3036112-LU
12328 33rd Ave NE
Recommendation Phase
25 August 2021
12328 33RD AVE NE LLC

12328 33rd Ave NE
SDCI #3036112-LU

The proposed project involves the demolition of an existing triplex building and the construction of an apartment building containing approximately 46 Small Efficiency Dwelling Units (SEDUs). No parking spaces will be provided.

EDG Enlarged Plan - Entry

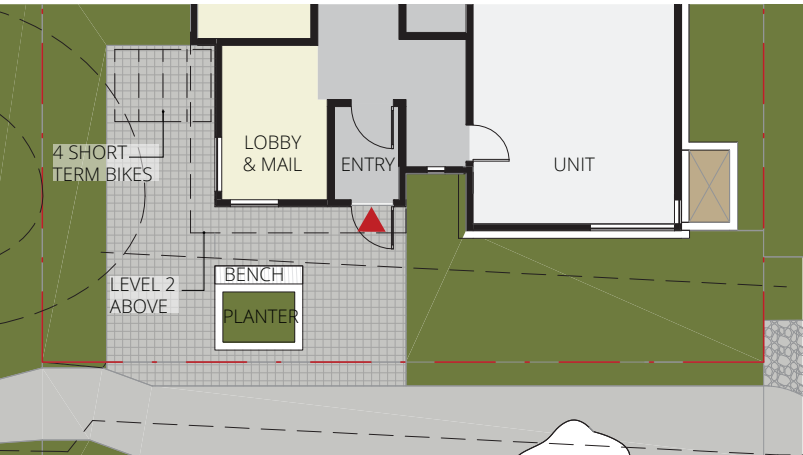
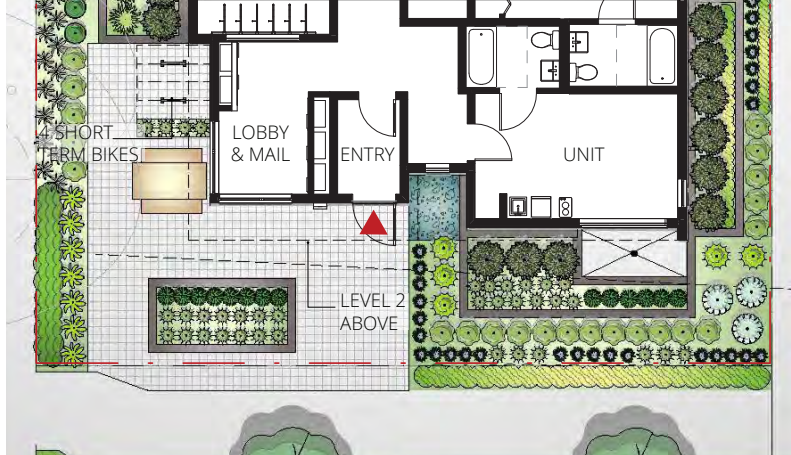
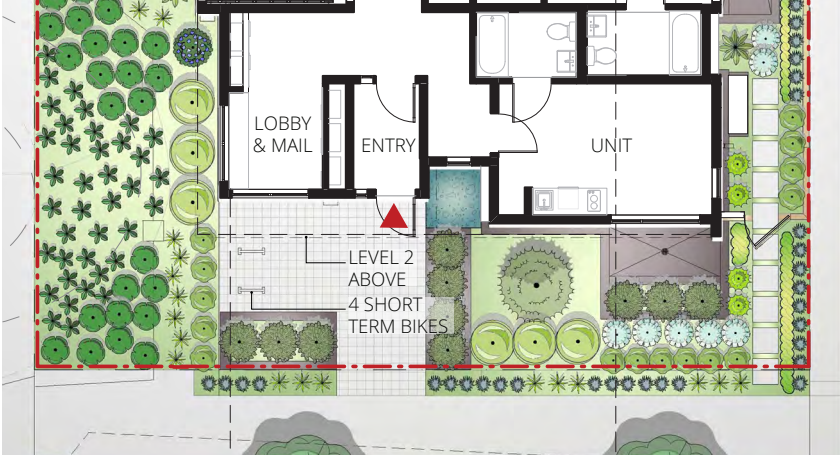
Correction #10. The landscape design at the northwest corner does not appear to provide a cohesive and layered design that promotes residential interaction and interest for pedestrians. There is no hierarchy of space, the large planter (which is 2.5’ high, not at bench height) in the middle of the space forces the only amenity (a picnic bench) t0 be forced into a corner, and the temporary bike racks are barely visible from the street. Revise the design of this area.

EDG
At EDG, the entry plaza formed an 'L' around the lobby, with a central planter. Bike parking was pushed back from the ROW. Lobby window sills were raised up. Window well is located on the south facade.

MUP
At MUP, the 'L' shaped entry plaza with planter and bike parking was maintained. A table with benches was added next to the bike parking. The window well was relocated to the west façade and terraced to provide more light for that basement unit. These updates were made in response to the EDG Report.

Recommendation
The entry plaza has been modified to provide a greater buffer for the north neighboring exceptional tree and a concise entry sequence. (Lake City Guideline CS1.I.) Proposed planting is lush and vibrant with seat-height planters that frame the entry. Bike parking has been relocated to a more visible but secure location between the planter and the lobby. Lobby window heights were increased to distinguish the building entrance. Other entry elements such as lighting, signage, and the callbox have been refined to provide a cohesive layout (Lake City Guideline PI3.I). These updates were made in response to a meeting with the Land Use Planner.

EDG Elevation - North

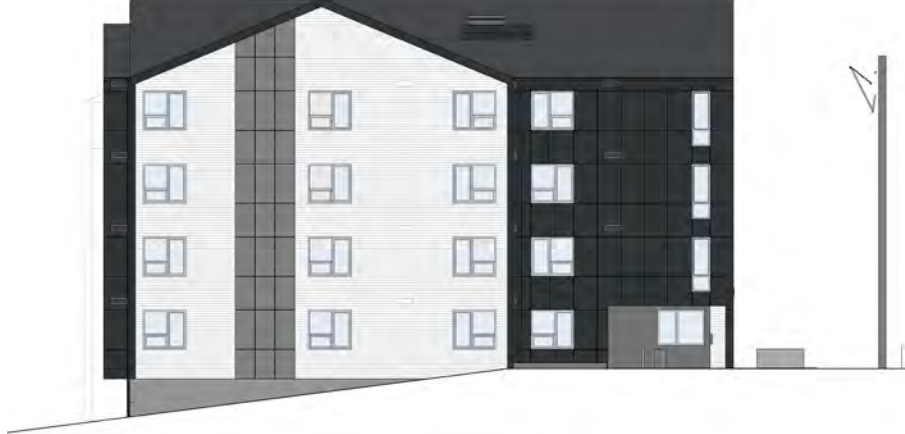
Correction #5. The north façade contains a lot of blank wall. The large gable form does help break down the overall height, bulk, and scale, however it does not provide adequate secondary architectural scale that is appropriate for a façade of this scale. Provided larger windows similar to those provided on the other gabled forms and other scaling elements to mitigate the blank facades. Also the large recess on the north façade is off center and not symmetrical like the east and west facades. Revise the modulation to fit with the architectural precedent set by the other facades and in coordination with the comment above.

EDG
At EDG, the proportions of the north gable match those of the west primary façade. A recess in the north elevation is offset within the gable. Windows are minimal, with the stair core occupying the east portion of the façade.

MUP
At MUP, a fin element wraps the north gabled mass. The stair core was relocated and replaced with a unit. Windows were widened. The vertical recess within the framed façade remained off-center, distinguishing it from both east and west framed facades. These updates were made in response to the EDG Report.

Recommendation
In the current design, the north framed façade is narrower to eliminate the offset recess. Windows are taller to match the proportions of the windows in the east and west framed facades. These changes allow the north facade to express itself in the same language used on the other facades for a cohesive design (Lake City Guideline DC2.iii). The gable roof's vertical extension frames the building modulation, creating clear proportions and establishing a hierarchy of elements that unify building composition. Proportions of the framed facades establishes the west façade as the primary façade and the north and east as secondary to the primary west facade (City Wide Guideline DC2.A.2). These updates were made in response to a meeting with the Land Use Planner.

EDG Enlarged Plan - East Yard

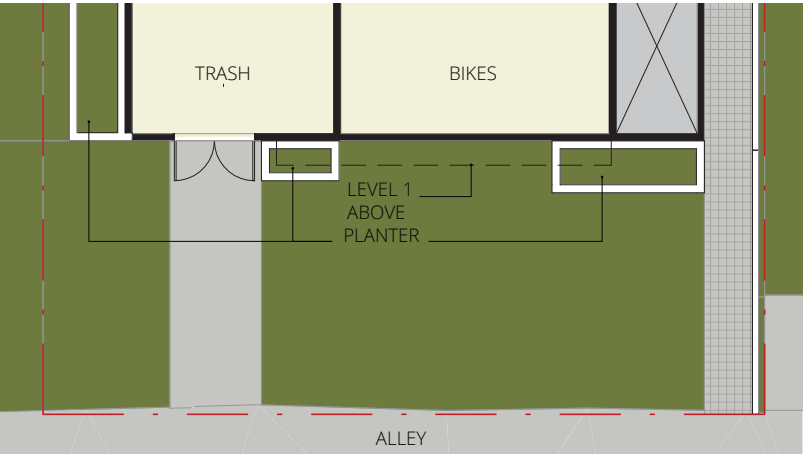
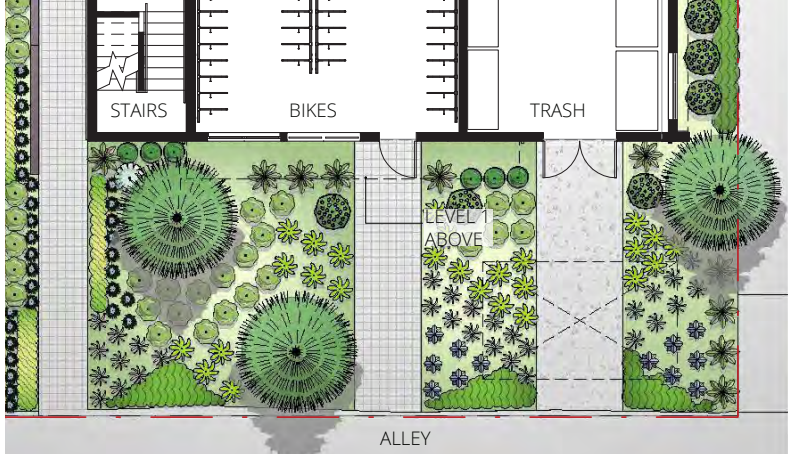
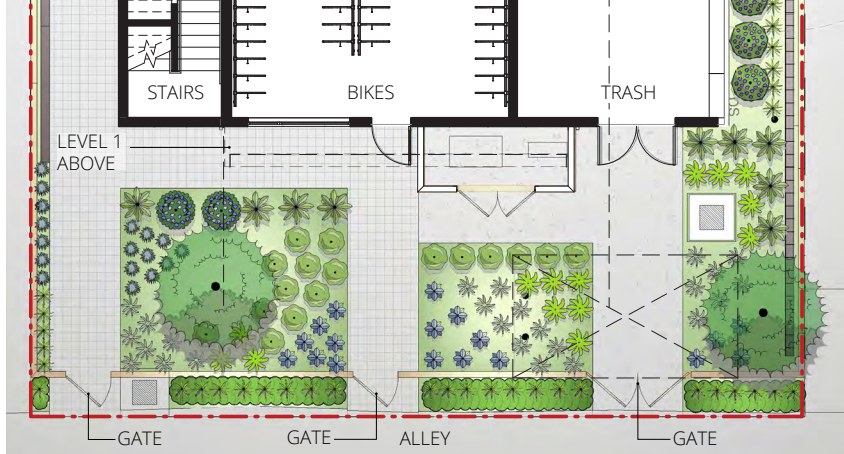
Correction #9. The relocation of the bike room in plan addressed the EDG guidance, however, the façade of the alley is still blank and the high windows do little to provide interest. Study lowering the sill of the bike room windows and making the door more transparent along with looking at the landscaping in this area. Look at adding an outdoor area with a bike station for fixing bikes, a place to wash bikes and seating that might serve as informal amenity space for residents.

EDG
At EDG, the trash room access was located to the south and exit access to the north.

MUP
At MUP, exit access shifted to the south and trash room to the north, and bike room access was added. Each walkway connected to the alley only, limiting interaction within the east yard. Windows were added at the bike room to increase visibility. These updates were made in response to the EDG Report.

Recommendation
In the current design, access paths connect to improve on-site circulation. Mechanical equipment is located between the bike room and the trash room, limiting mechanical and trash services to the north side of the yard (Citywide Guideline DC1.C.4). The bike room windows are taller and the bike room door full-lite with glazing. A 6' tall wood fence wraps the east yard for security and provides a gate at each access path from the alley. Proposed planting is lush and vibrant, creating visual interest from the alley and a buffer between the ROW and the building. These updates were made in response to a meeting with the Land Use Planner.

Window Well Sections - Scale: NTS

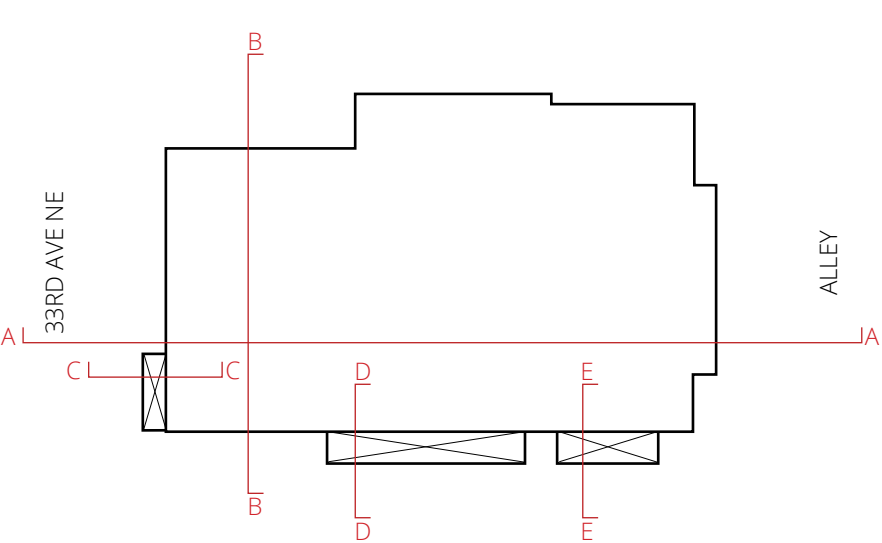
Correction #7. It appears that the window well associated with unit B01 has been moved from the south side to the north and it is unclear what this condition looks like. Per EDG guidance, outdoor terrace space is a more appropriate way to meet the intent of street level/facing design guidelines. If this window well condition is part of a larger landscape design approach to the front of the building, provide sectional information that describes the relationship to grade.

⑤ At EDG, staff expressed concerned about limited access to light and air for the basement units. The deepest window well condition at the southwest corner of the building has been terraced to provide that unit with more light and air. Planting around each window well provides a layer of privacy and strengthens the connection with the exterior. Sections have been included with more information about window well dimensions. All window wells will be concrete, and no guardrails are required.
